RE: Beacon Solar Energy Project's Response to California Energy Commission Data Adequacy Recommendation

# BEACON SOLAR ENERGY PROJECT

Volume 3 Data Adequacy Supplement

**Response to CEC Staff Data Adequacy Comments**

**Figure 5.3-9**  
**Future Survey Areas**  
**2 of 2**

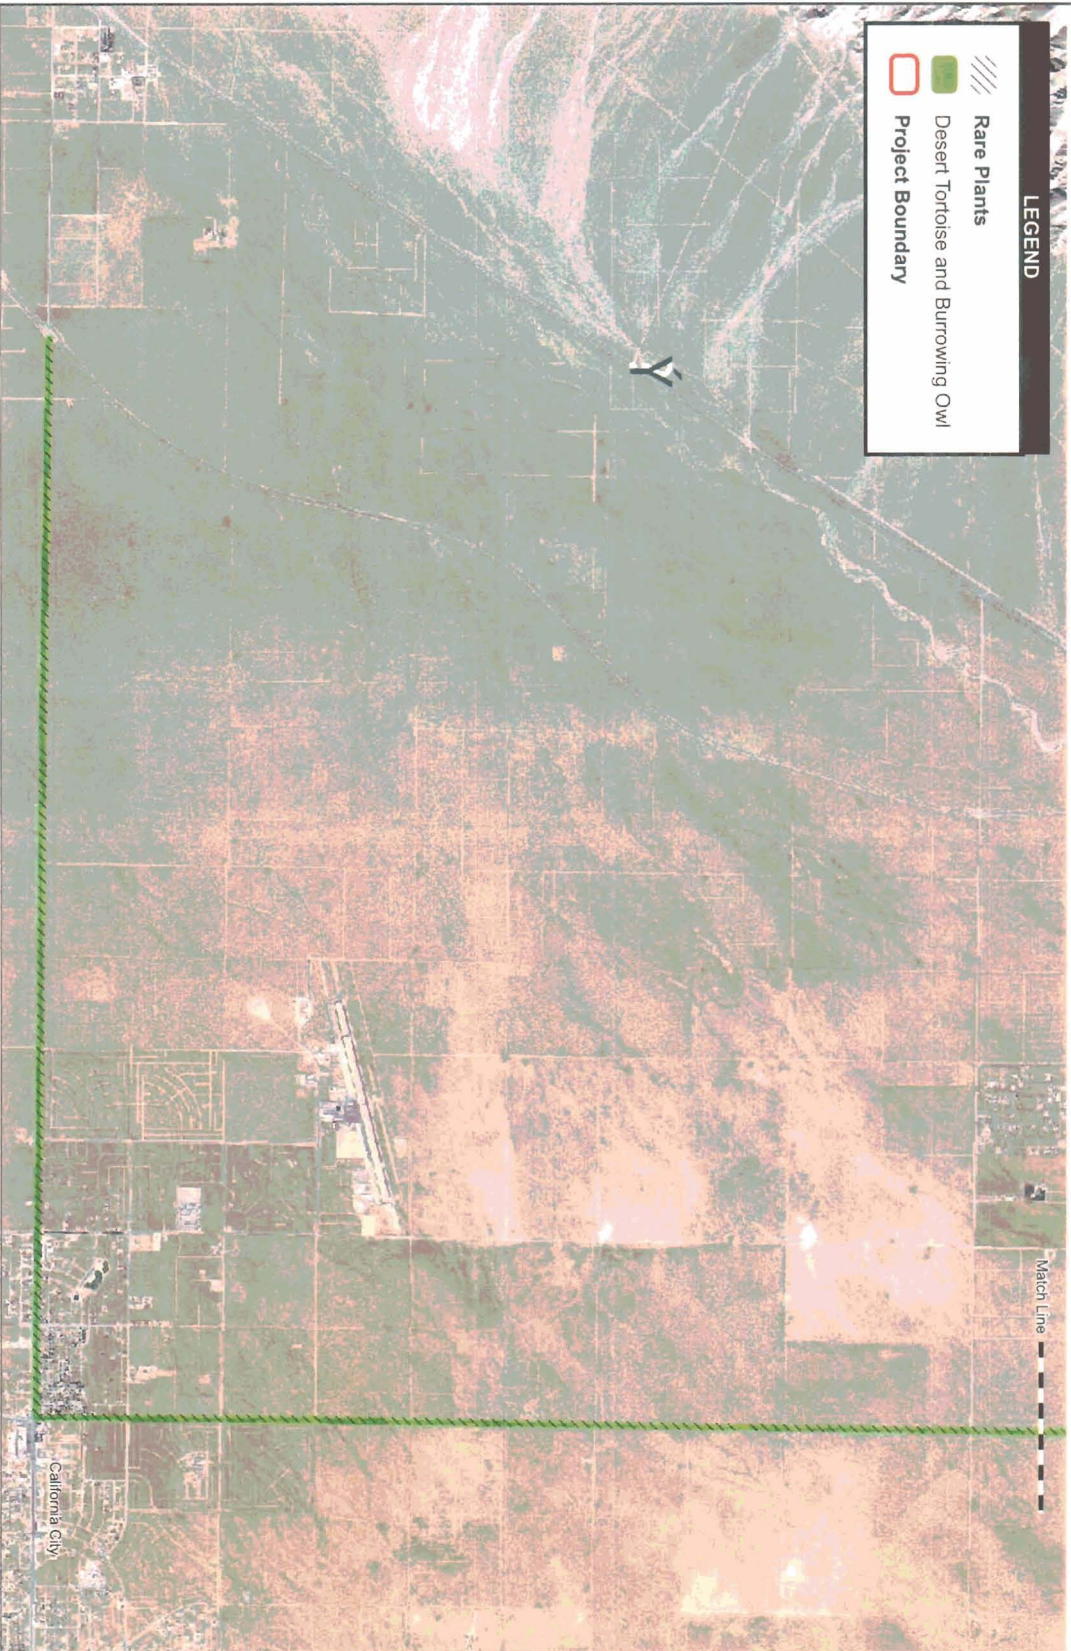
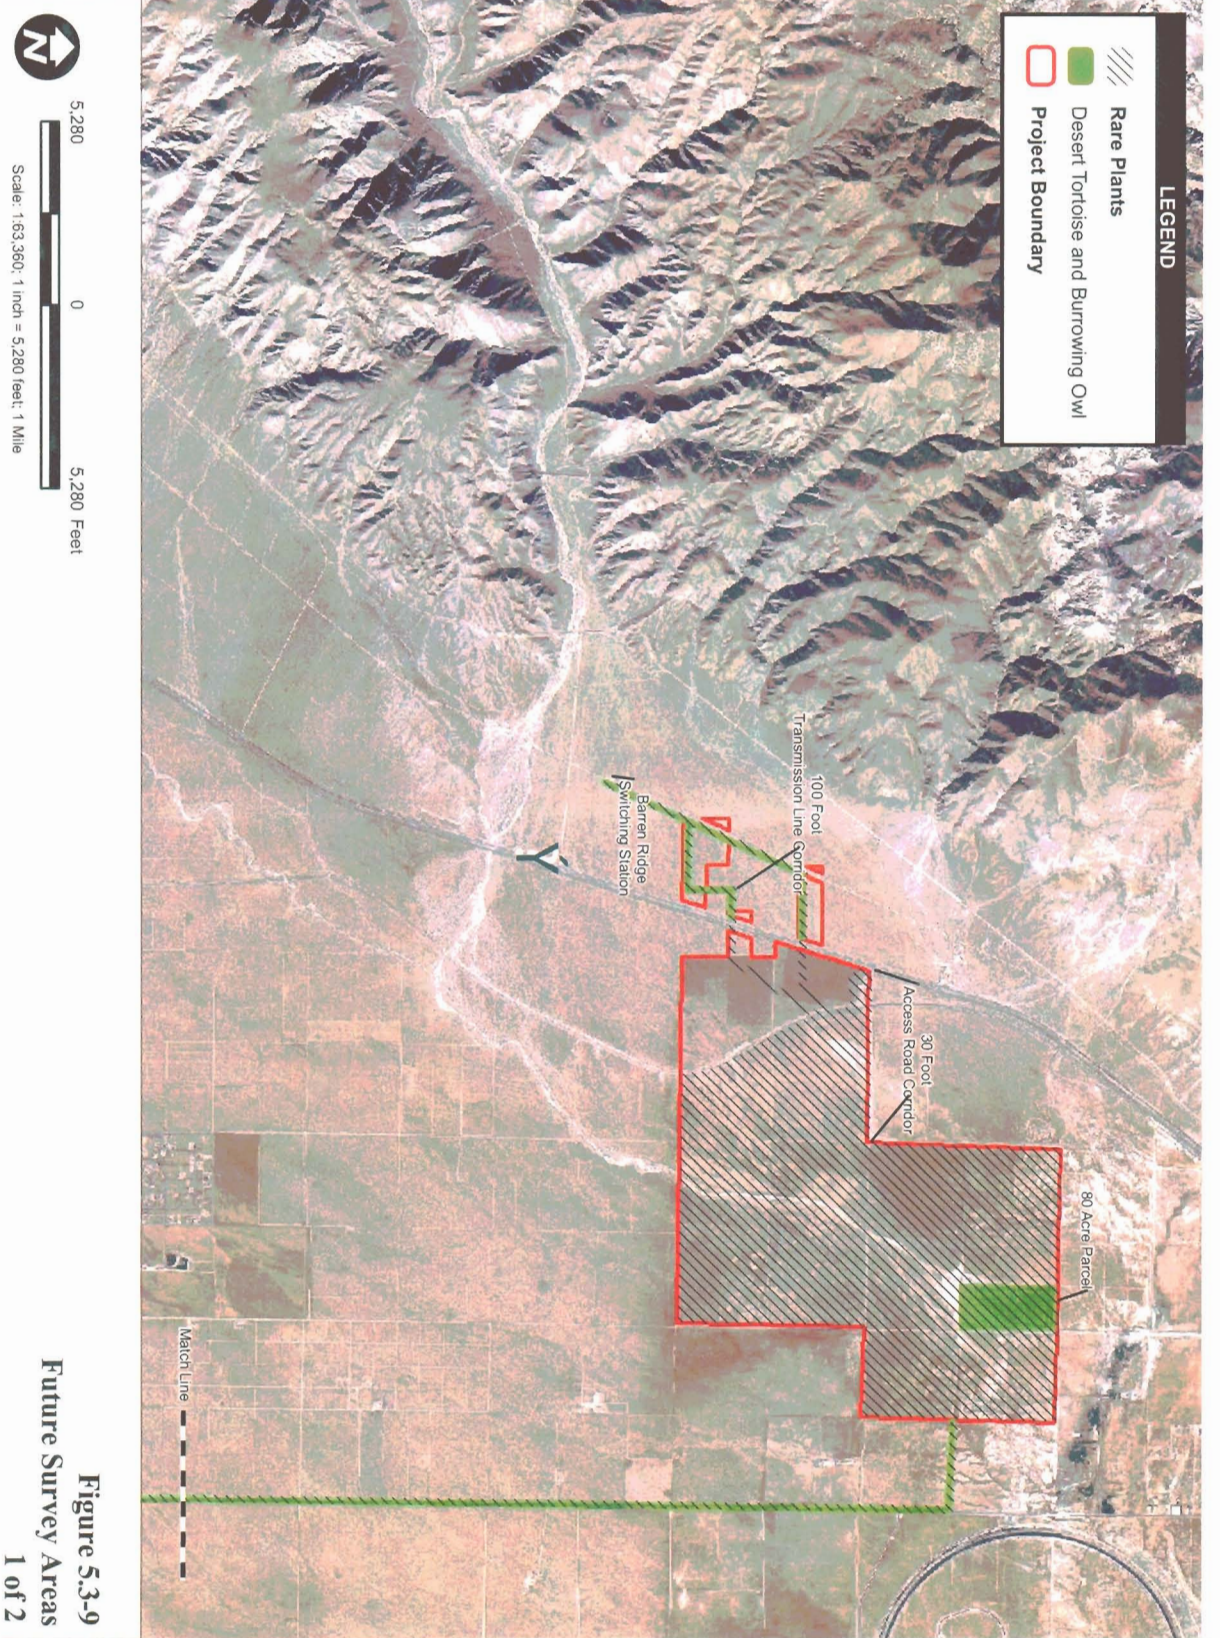
In areas yet to be surveyed discussed in Section 5.3.2.4, page 5.3-9, please provide a detailed discussion of when, where, and what the surveys in 2008 will entail.

The new Figure 5.3-9 shows the areas where biological surveys are being conducted during appropriate periods of the spring of 2008 (because these had not yet been clearly defined as part of the project description at the time surveys were conducted in the spring of 2007). These areas include the approximately 80-acre addition to the northeast portion of the plant site, an approximately 100-foot wide band adjacent to the north side of the existing access road from SR-14 on the northern boundary of the plant site, the two transmission line route options, and the natural gas pipeline route. Of the four distinct survey areas, three of the areas (i.e., the 80-acre addition, the narrow band north of the existing access road, and transmission line route options) were surveyed to a large degree during the spring of 2007 because they all fall within areas where multiple zone of influence (ZOI) transects were walked (see Figure 5.3-4 in Volume 1 of the AFC). While Beacon Solar believes that those 2007 multiple ZOI transects serve to adequately define the environmental baseline for those areas for purposes of evaluating environmental impacts, we felt it prudent to conduct full, 100% coverage surveys for these areas this spring (2008) to ensure there would be no data gaps. Only the natural gas pipeline route outside of the plant site boundaries was not surveyed during 2007. As noted in the AFC, all gas pipeline construction/operations/maintenance activities would take place entirely within already disturbed roads and rights of way. Nevertheless, Beacon Solar is conducting the requisite 1000-ft buffer surveys this spring (2008) on both sides of the gas pipeline centerline.

In the spring of 2008, all four areas are being surveyed for 1) special status plant species, 2) desert tortoise (*Gopherus agassizi*), 3) western burrowing owl (*Athene cunicularia*), and 4) general floral and faunal species (including mapping of any additional areas of vegetation, and any incidental occurrences of special status species not targeted during the surveys described). Because of the low rainfall associated with the spring of 2007, the special status plant surveys will also cover the entire plant site, and all associated linear features (i.e., the transmission line route options and the natural gas pipeline route), with the exception of the highly disturbed road and shoulder along Neuralia Road where the gas pipeline would be installed. This road shoulder is routinely maintained to be kept free of vegetation, which was one of the factors in selecting the route for the

natural gas pipeline. The desert tortoise and western burrowing owl surveys will cover the 80-acre addition, the narrow band north of the existing access road to the plant site from SR-14, and the portions of the transmission line route options and natural gas pipeline route outside the plant site boundaries that were previously surveyed with numerous ZOI transects during the spring of 2007.

**Figure 5.5-4**  
**Project Linear Features vs.**  
**Alquist-Priolo Fault Zones**

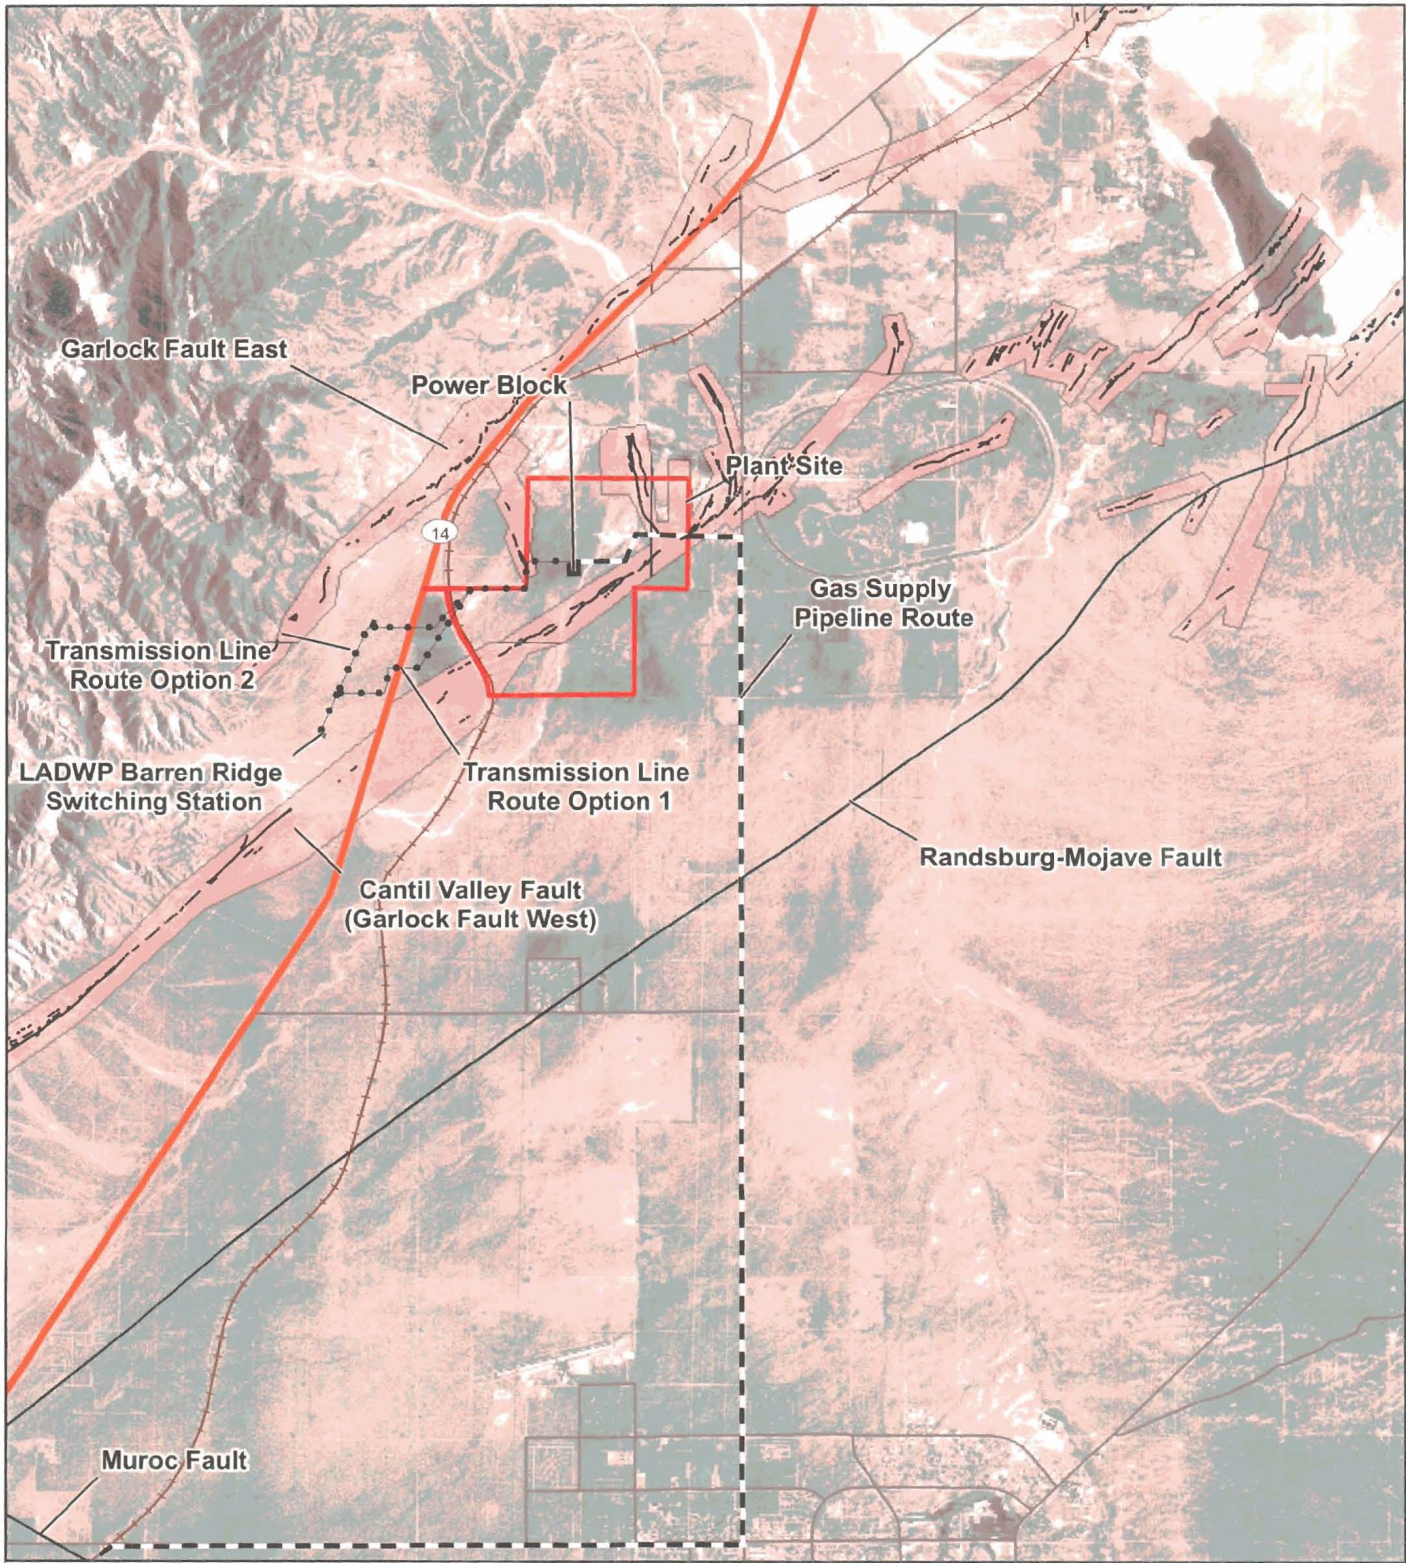
Summary of geology and seismicity along related linear facilities.

Discussion of linear facilities in Section 5.5.2.3.

The BSEP offsite linear facilities consist of: 1) a natural gas pipeline extending approximately 16.4 miles off the plant site (with an additional approximately 1.2 miles of the pipeline within the plant site boundary), and 2) two transmission line options, each extending approximately 1.9 miles in total off the plant site (with approximately 1.6 miles of both routes within the plant site boundary). Along with the power plant site, these facilities are located in the alluvial-filled basin of the Fremont Valley, southeast of the Tehachapi Mountain foothills. Topography along these linear facilities is relatively flat and is underlain by Quaternary-age alluvium, Holocene lacustrine and playa deposits near the surface, and older alluvium at depth. The majority of the linear facilities are within Arizo gravelly loamy sand, Cajon loamy sand, Cajon gravelly loamy sand, Rosamond Clay loam, Rosamond clay loam, saline-alkali, and Garlock loamy sand soil types. The runoff potential of these soils is negligible to moderate and water and wind erosion hazard is moderate to high. There are no permanent bodies of water located along the route of the linear facilities.

The linear facilities are located in seismically active Southern California and a review of the Kern County Online Mapping System (2007) and the Alquist-Priolo Earthquake Fault maps (Division of Mines and Geology 2000) indicate that two AP fault zones are in the vicinity of the routes of the linear facilities (the locations of AP faults zones with respect to linear facilities are shown on new Figure 5.5-4). The transmission line options fall between the Garlock East Fault and the Garlock West Fault, and the offsite gas pipeline crosses the Garlock West Fault at the plant site boundary. The origination point of the gas pipeline (west of California City) is approximately 12 miles from the Garlock West Fault. The expected relative Peak Acceleration for the Garlock East and West Faults is 0.37g. In addition, the gas line crosses the Randsburg-Mojave Fault and a portion of the Muroc Fault. The portion of these faults have not been mapped as AP zones.

The section of the gas pipeline that crosses the AP zones is subject to surface rupture from active faults and therefore the risk of earthquake-induced ground rupture would be considered significant before mitigation. Neither linear facility is located in an area with the potential for permanent ground displacement due to earthquake-induced landslides because surface topography at and near the linear facilities is relatively flat, even for the transmission line where it approaches the foothills.

**Figure 5.7-7**

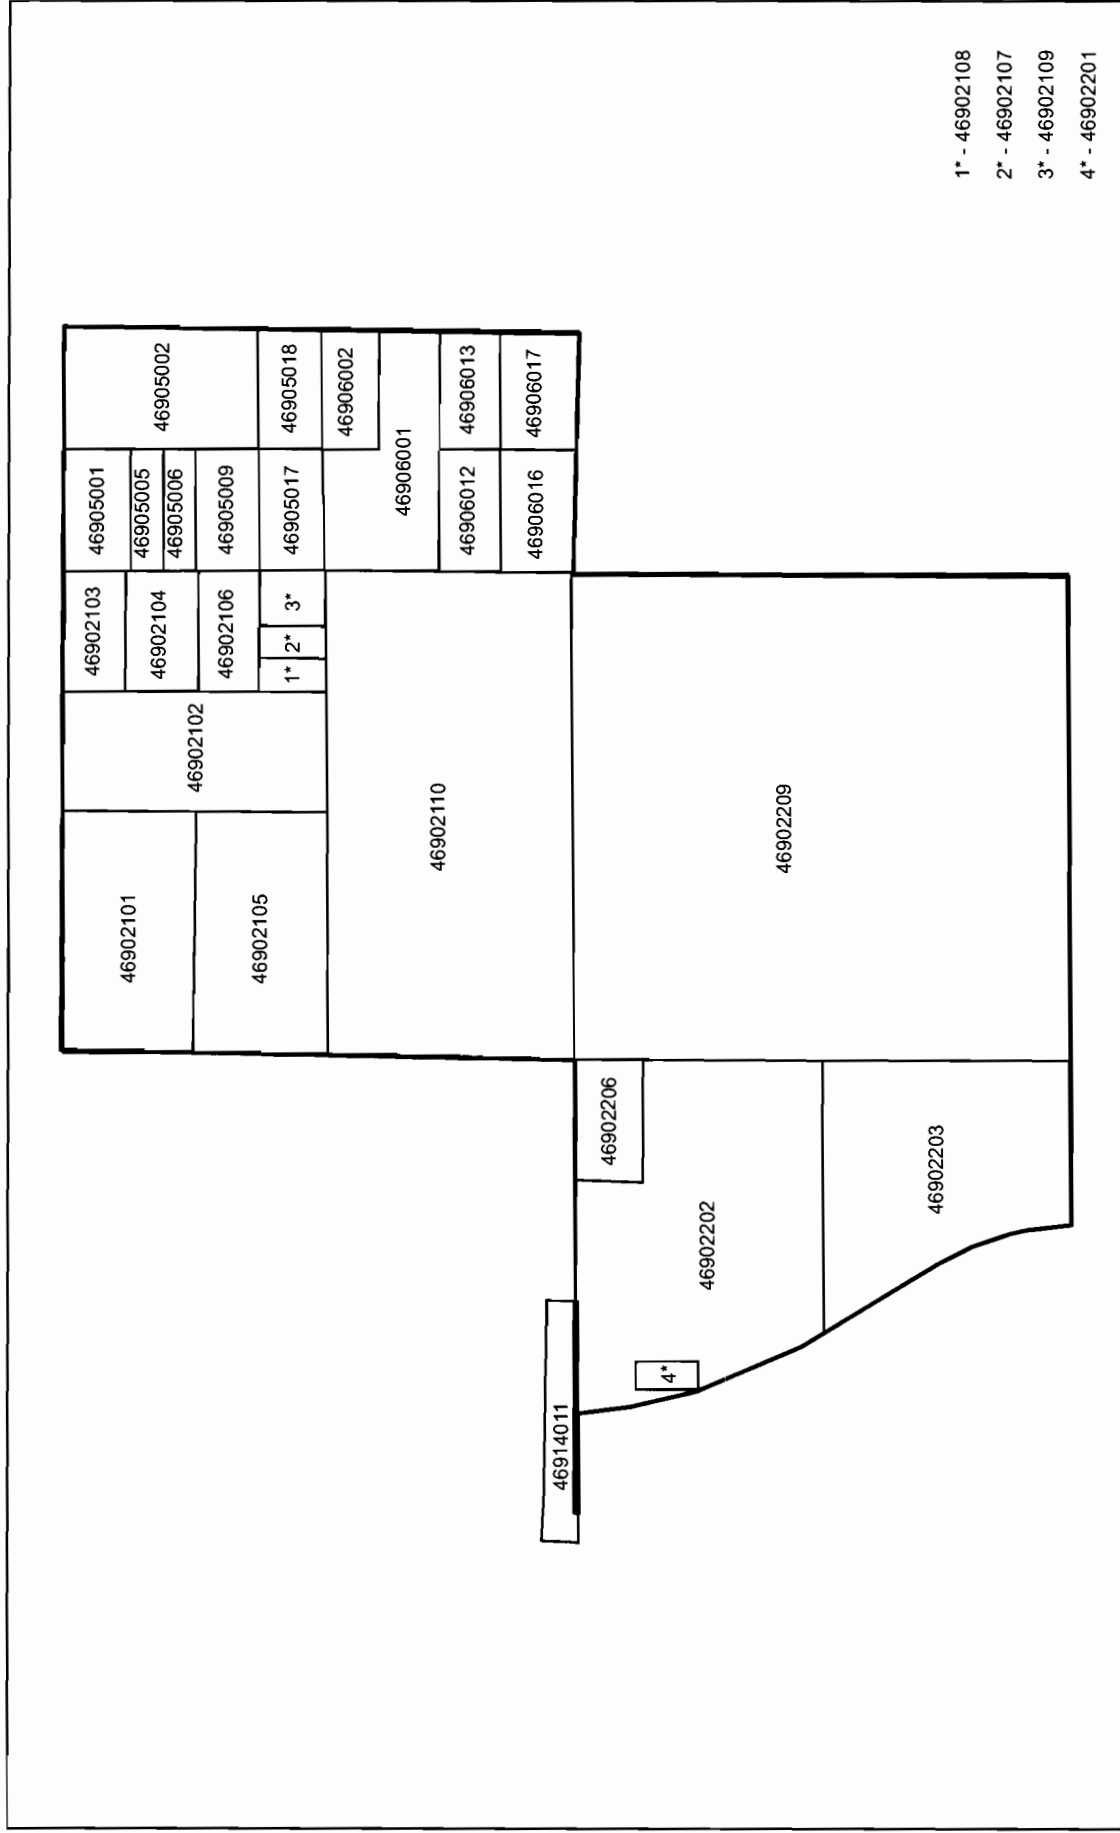
The cover letter for the AFC submission indicates that Beacon Solar intends to "develop, construct, own, and operate the proposed new facility on land owned by the company". There is no discussion within the AFC regarding current land ownership, legal status of the parcels, or method and timetable for merging or combining the multiple parcels. Please provide a discussion of the current land ownership, legal status, intent regarding transfer of title, and method/timetable for merging or combining the multiple parcels (excluding linears and any temporary use areas).

The BSEP 2012 acre site, excluding linears (and the Project will not utilize offsite temporary laydown or staging areas), consists of 29 separate assessor parcels (see new Figure 5.7-7). Beacon Solar owns 26 of the 29 parcels contained within the Project site boundary. Beacon Solar has entered into purchase arrangements for the remaining parcels within the site area not yet owned by the Applicant, and expects to close the purchase of these remaining parcels in the near

future. The remaining parcels comprise approximately 29.5 acres of the total 2012 acre project site area.

The parcels that comprise the site were all created by previous owners by deed and are not the result of any formal subdivision process. Prior to the start of construction, BSEP will process and record a subdivision map with Kern County to combine the separate parcels into a single legal lot. To ensure that this process is completed in a timely manner, Beacon Solar plans to initiate this process in the summer of 2008.
